Florida Municipal Power Agency
Treasure Coast Energy Center

B&V Project 138859
B&V File 35.5500
July 28, 2005

Re: Florida Municipal Power Agency
Treasure Coast Energy Center
Site Certification Application No. PA 05-48
DOAH Case No. 05-1492EPP

Response to Statement of Insufficiency Treasure Coast Energy Center July 29, 2005

SCA Figure 2.3-5. FLUCCS Land Use

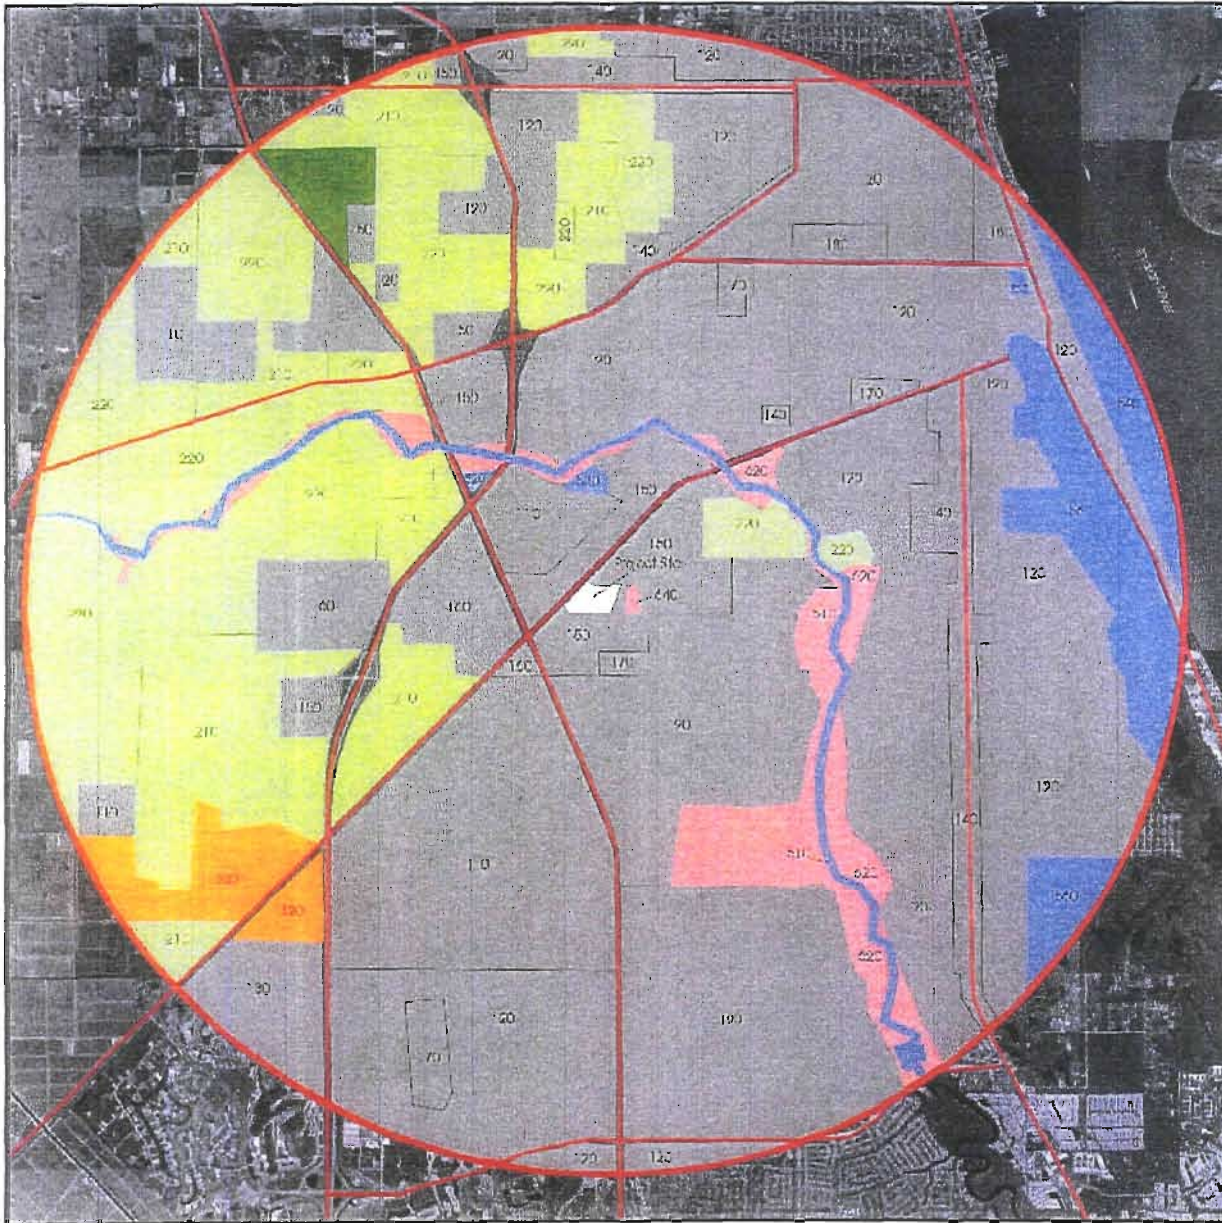
Figure 2.3.5 FLUCCS Land Use is missing.

Due to a copying error, Figure 2.3-5 was not included in some copies of the SCA. One copy of Figure 2.3-5 is provided with this response in Appendix A. Please insert this figure into your copy of Volume 1 of the SCA following page 2-57 (Figure 2.3-4). Additional copies of this figure are available upon request to FMFA.

Project	Drawing	Rev
138859.0030	WMB-9	1
Figure 3.5-6

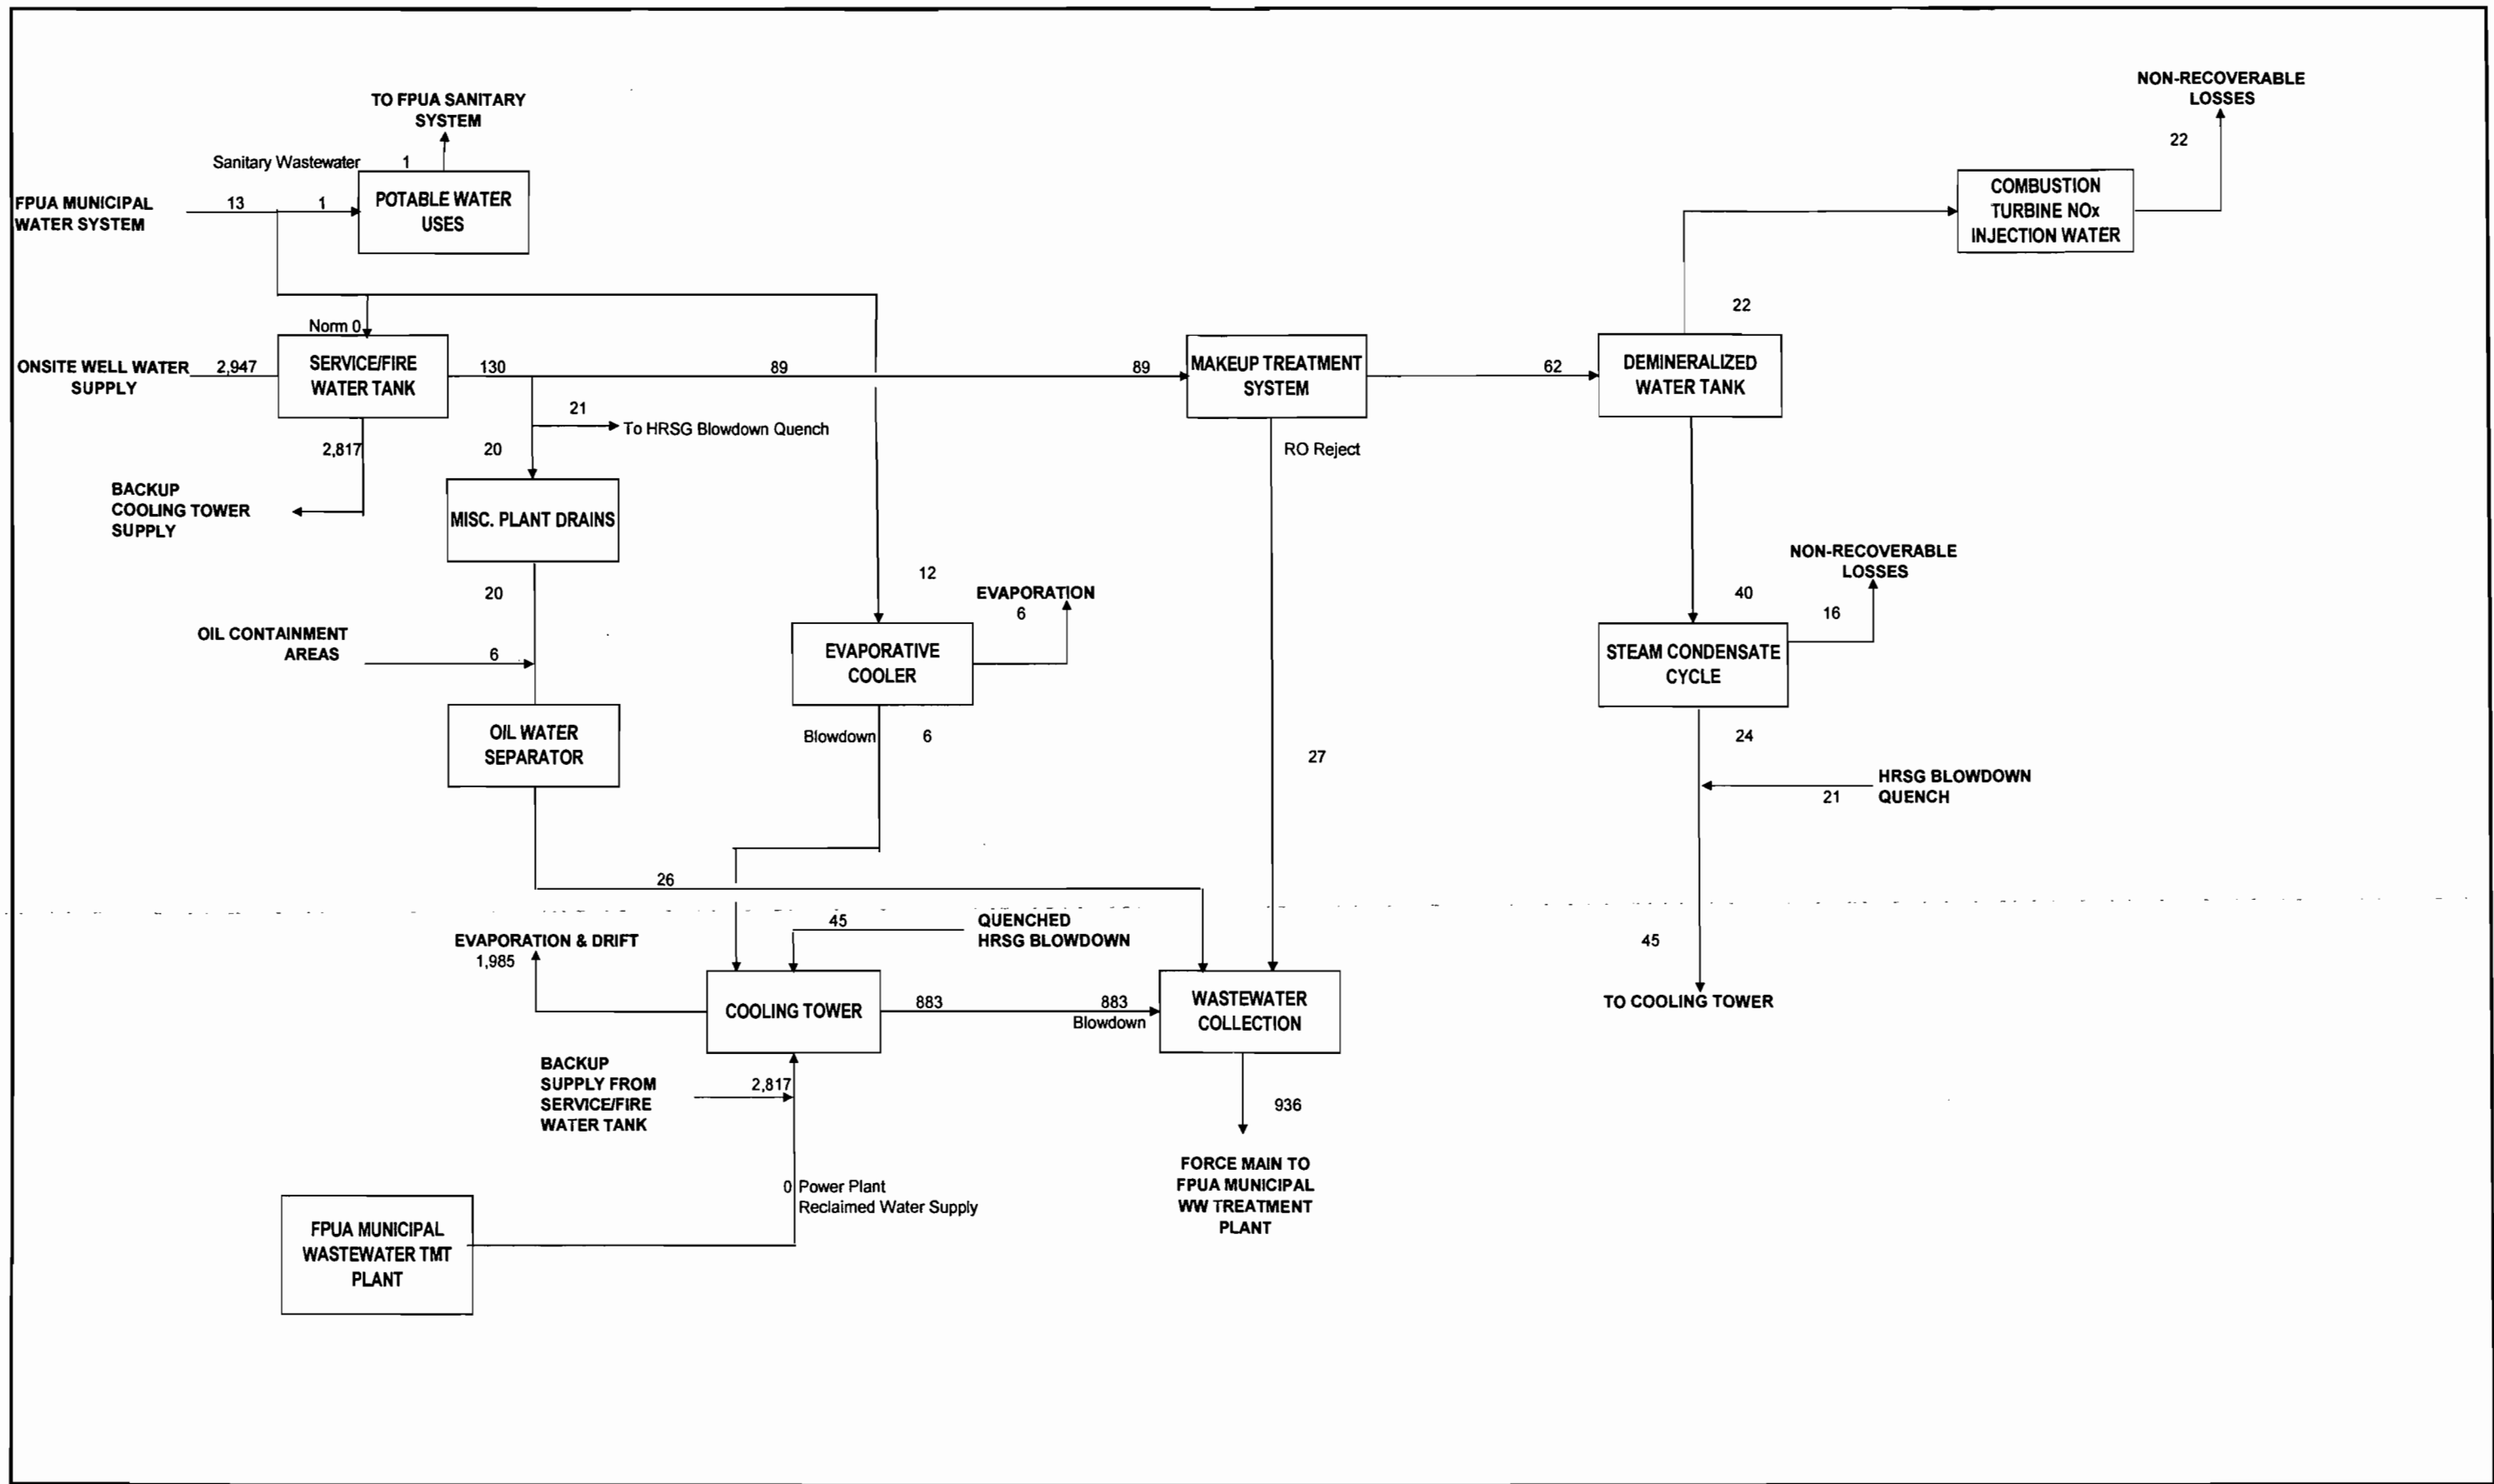
Figure 3.5-6 shows 942,000 gpd as the annual average of wastewater going to the injection well, not the 889,000 gpd reported in the text. Please clarify.

Figure 3.5-6 (Water Mass Balance-9) indicates the annual average when well water is used as cooling tower makeup. Because of differences in water quality, more blowdown is required when using well water makeup rather than reclaimed water in order to maintain water quality in the circulating cooling water system and the cooling tower.

Also for water quality reasons, FMPA will use potable water from FPUA in the evaporative cooler rather than well water. Revised water mass balances indicating this change are included Appendix L.
